Subject ▶ Change of Housing Set and screws

For Models ▶ 6172D,6172DW(Cordless Driver Drill)

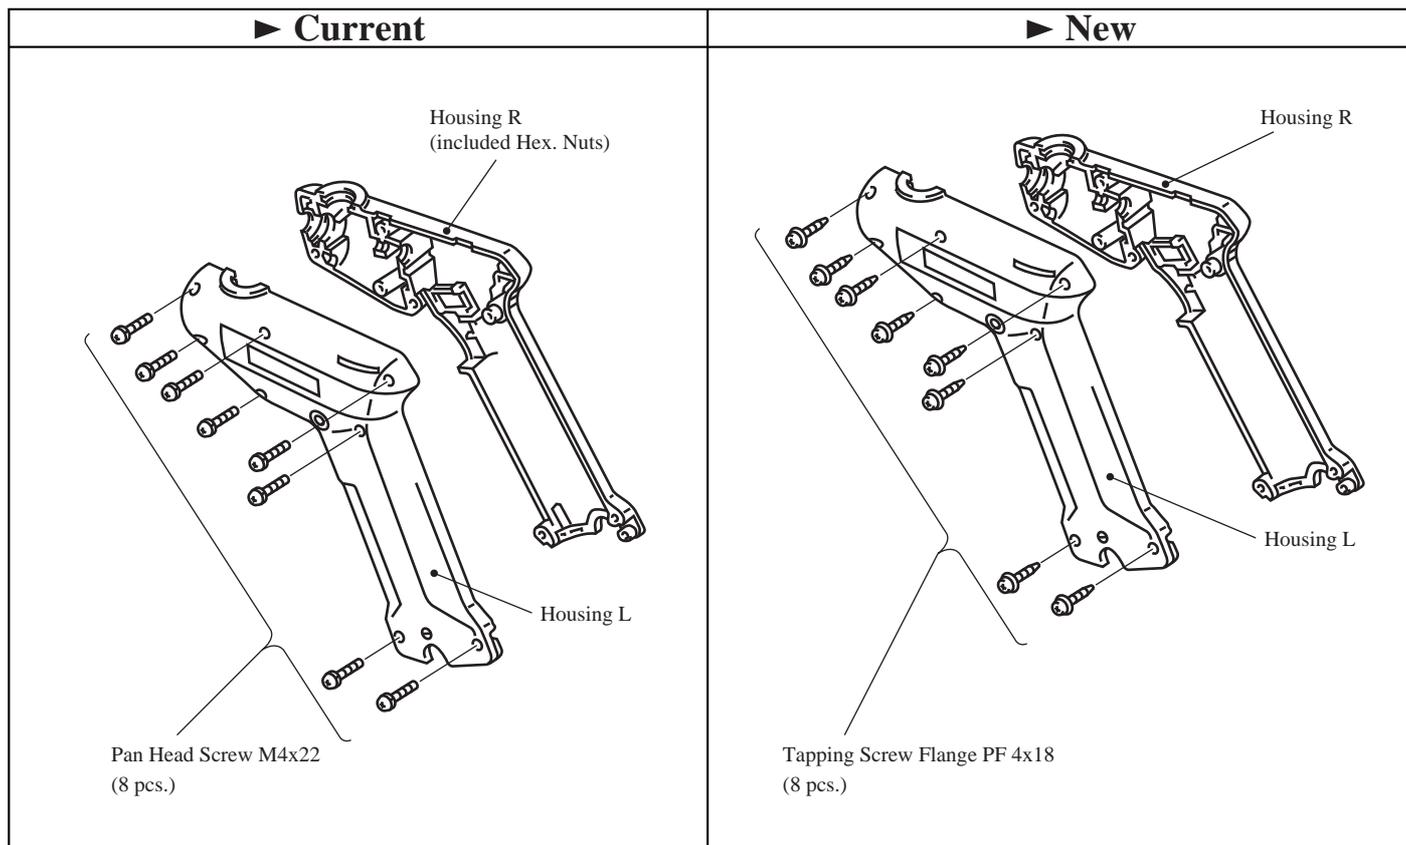
Description ▶ As illustrated below, Housing Set and screws have been changed.

1)Change of screws

Screws have been chaged to self-tapping screws.

2)Change of Housing Set

Bosses of Housing R for screws have been changed.
